Corrections & Updates

Mini Preamp

October 2009, p. 68-71, ref. 090241-1

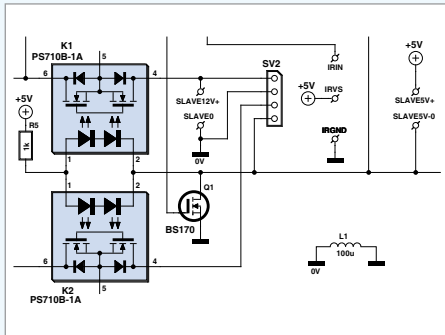
Regrettably a few errors have crept into the circuit diagram in Figures 1 and 2. In Figure 1, components K1 and K2 are drawn incorrectly and an inductor is missing between the analogue and digital ground lines.

In Figure 2, the relay contacts are drawn incorrectly in their non-actuated state, which suggests all inputs are interconnected. Also, two miniature chokes are missing in the +12 V and -12 V supply lines.

The corrected sections of the circuit diagrams are shown here. The electronic version (.pdf) of the article on the Elektor website contains the corrected diagrams.
